# Baseline proposal for 100, 200 and 400 Gb/s Backplane

## Changes to Annex 93A to implement this proposal (1 of 3)

## Changes to Annex 93A to implement this proposal (3 of 3)

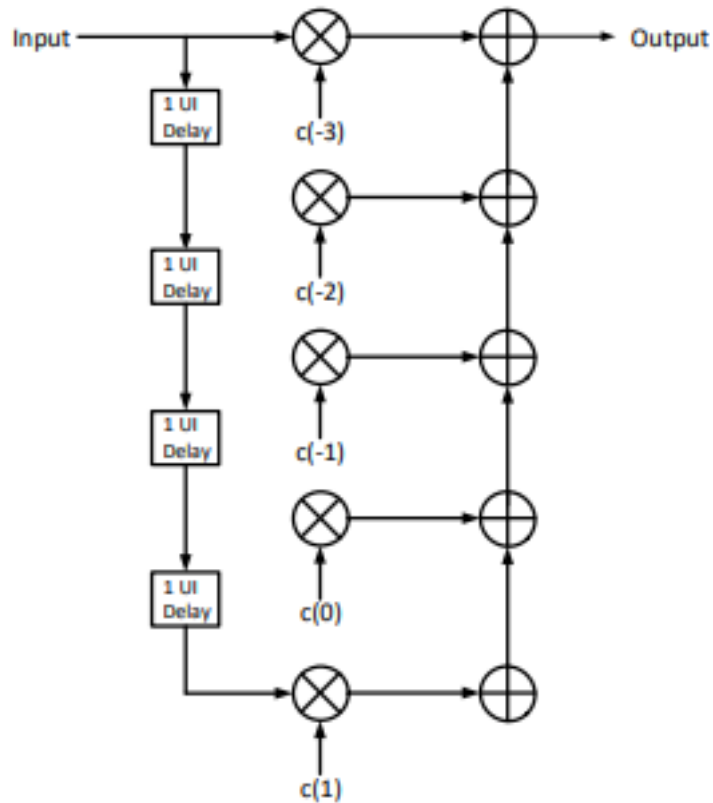
The scattering parameters for the transmitter device package model  $S^{(tp)}$  are the result of the cascade connection of the device **capacitance**[model](#), package transmission line, and board capacitance as defined by Equation (93A–15) [and Equation \(93A–15a\)](#).

Similarly, the scattering parameters for the receiver device package model  $S^{(rp)}$  are the result of the cascade connection of the board capacitance, package transmission line, and device **capacitance**[model](#) as defined by Equation (93A–16) [and Equation \(93A–16a\)](#).

$$S^{(td)} = \text{cascade}(\text{cascade}(S^{(d)}, S^{(s)}), S^{(b)}) \quad (93A-15)$$

$$S^{(tp)} = \text{cascade}(\text{cascade}(S^{(td)}, S^{(l)}), S^{(p)}) \quad (93A-15a)$$

$$S^{(rd)} = \text{cascade}(\text{cascade}(S^{(b)}, S^{(s)}), S^{(d)}) \quad (93A-16)$$

$$S^{(rp)} = \text{cascade}(\text{cascade}(S^{(p)}, S^{(l)}), S^{(rp)}) \quad (93A-16a)$$
